UNITED STATES
NUCLEAR REGULATORY COMMISSION
WASHINGTON, D. C. 20555

The Commission has issued the enclosed Amendment No. 11 to Facility Operating License No. DPR-71 for Unit No. 1 and Amendment No. 37 to Facility Operating License No. DPR-62 for Unit No. 2 of the Brunswick Steam Electric Plant. These amendments consist of changes to the licenses for both units and to Appendix A-Prime of the Unit No. 1 license and are in partial response to your submittals of December 29, 1976, June 23, August 23, August 24 and September 20, 1977.

BRUNSWICK STEAM ELECTRIC PLANT, UNIT NO. 1

BRUNSWICK STEAM ELECTRIC PLANT

MANAGEMENT ORGANIZATION CHART
FIGURE 6.2-1

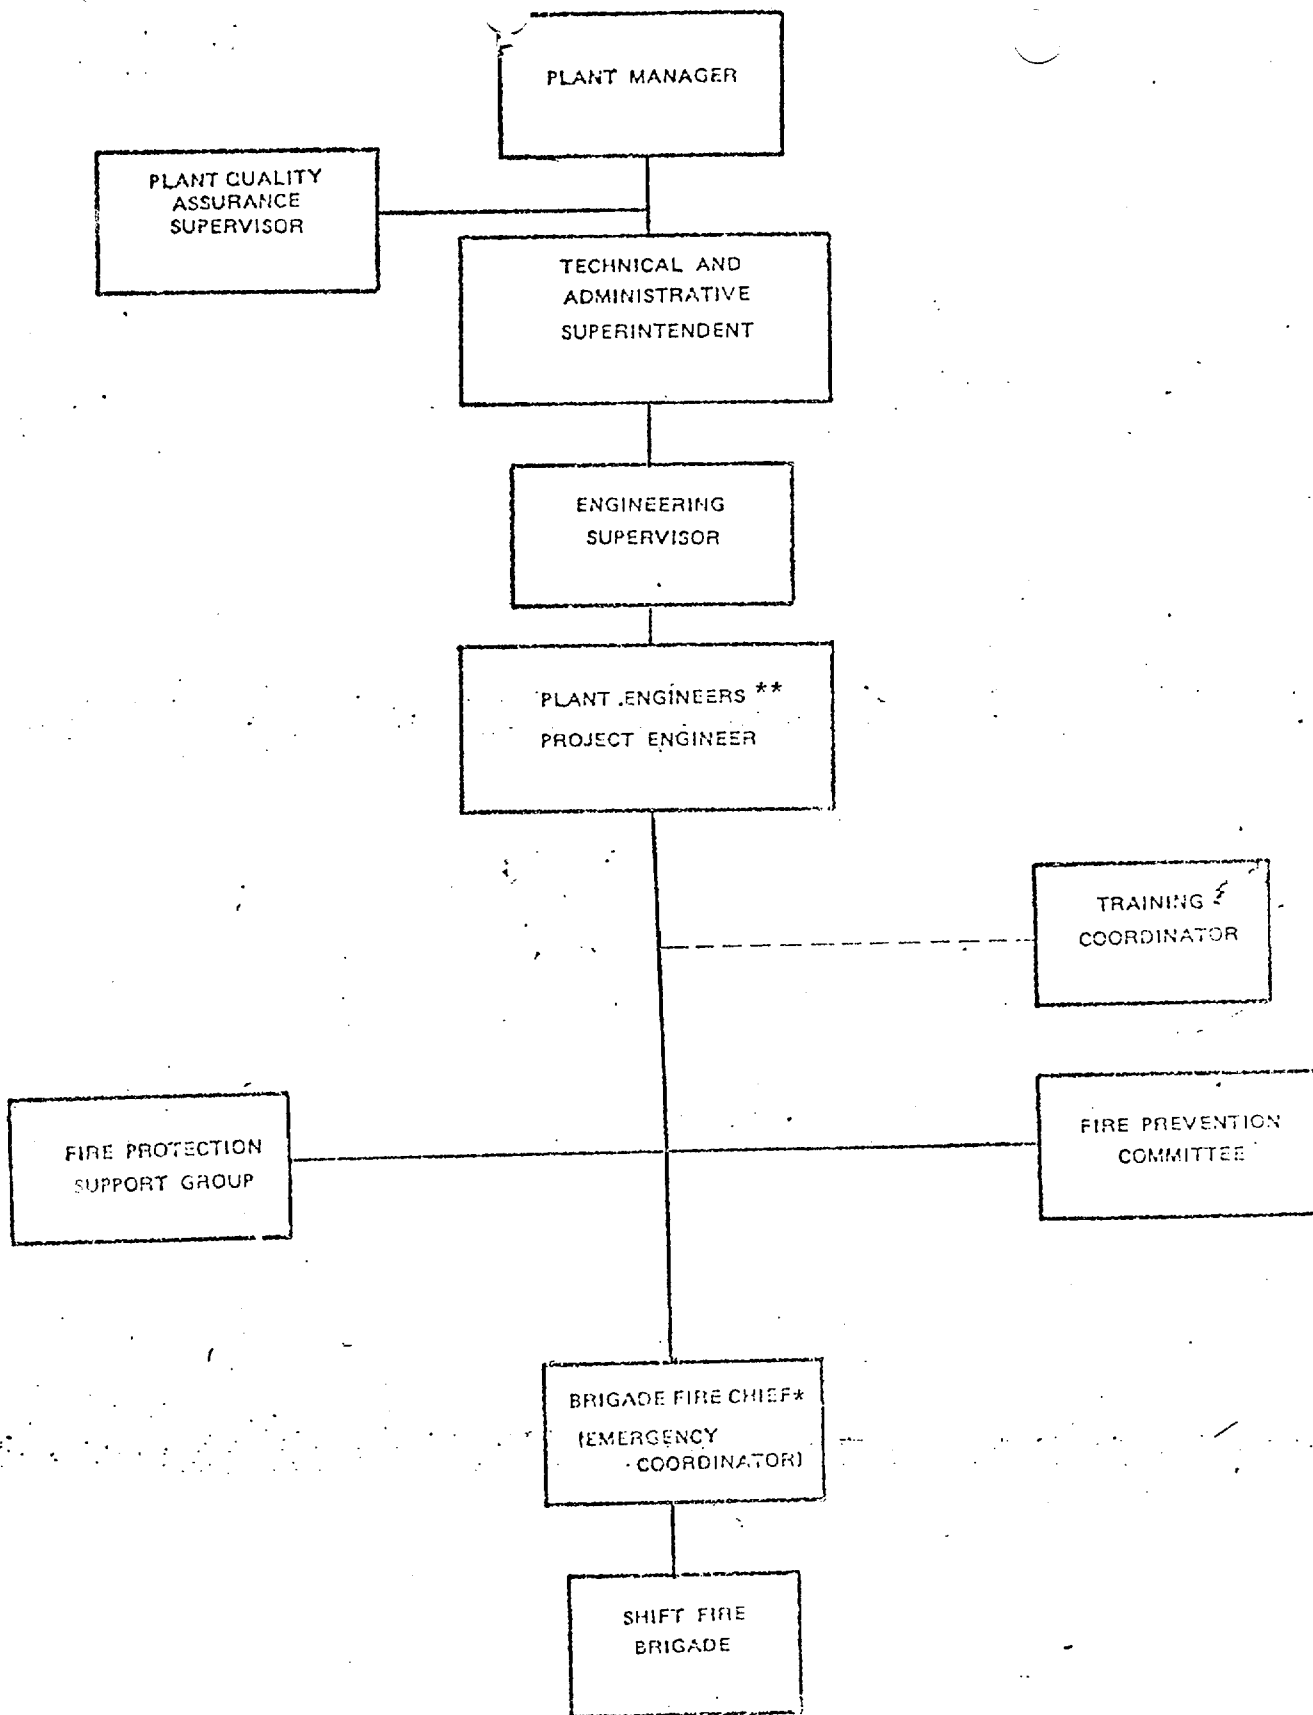
- f. A Fire Brigade of at least five members shall be maintained onsite at all times. The Fire Brigade shall not include the minimum shift crew shown in Table 6.2-1 or any personnel required for other essential functions during a fire emergency.

*Responsible for performance and monitoring of Fire Protection Program.
